P-9224 24807

ISSUE-2

NAME	DATE
(JINDAL)	JINDAL ALUMINIUM LTD.	DRAWN	J.P.KAUSHI	10-04-2018
SYMBOL OF QUALITY		CHECKED		
AN ISO 9001 COMPANY	BANGALORE-560073 (INDIA)	APPROVED	B.NATARAJA	16-04-2018
1. ALL DIMENSIONS ARE IN mm. 2. ROUND OFF ALL SHARP CORNERS WITH 0.40 mm. 3. TOLERANCES WILL BE AS PER IS:6477-1983 UNLESS OTHERWISE SPECIFIED		SCALE		1:1
		AREA mm ²		461.743
		PERIMETER	mm.	345.756
PARTY'S NAME	GENERAL CATEGORY, MUMBAI MARKET	WEIGHT kg,	/m	1.247
		DRAWING	No. SE	CTION No.
PARTY'S DRAWING No.	AS PER SAMPLE	P-9224 -		_
	LIEO WD	24807 2480		07(ISSUE-2)
ALLOY & TEMPER	HE9 WP			
DESCRIPTION	TEXTILE SECTION

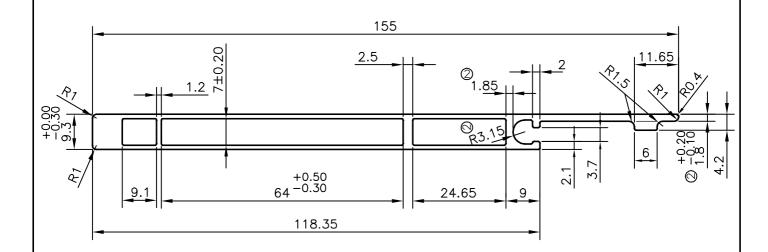
RADIUS CHANGED FROM R3.5 mm TO R3.15mm,
THICKNESS CHANGED FROM 1.5 mm TO 1.85 mm, FROM 1.6 mm TO 1.8 mm
& TOLERANCE ADDED

WEIGHT ALSO CHANGED FROM 1.217 TO 1.247 kg/m
